Subject: FW: HA3 - Land North of Barkby Road (LPA Ref: P/21/2639/2)

Please see our comments below which refer to the attached improvement scheme for the **Goodes Lane/Melton Road** junction.

Figure 6.25N2 Passing bay dimensions

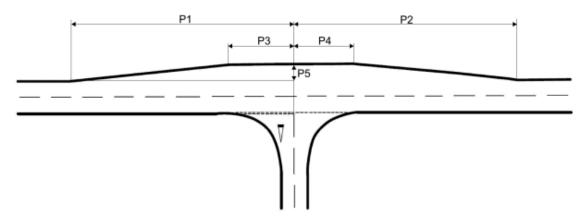
- It looks like a hybrid between a ghost right hand turn and a passing bay (see screenshot of figure 6.25N2 from CD123 below), but not really hitting criteria for either of them.

- We have checked dimensions against table 6.25N2 (shown below) Geometric parameters for a passing bay for car and HGV and it is not compliant, it would be ok for car and car.
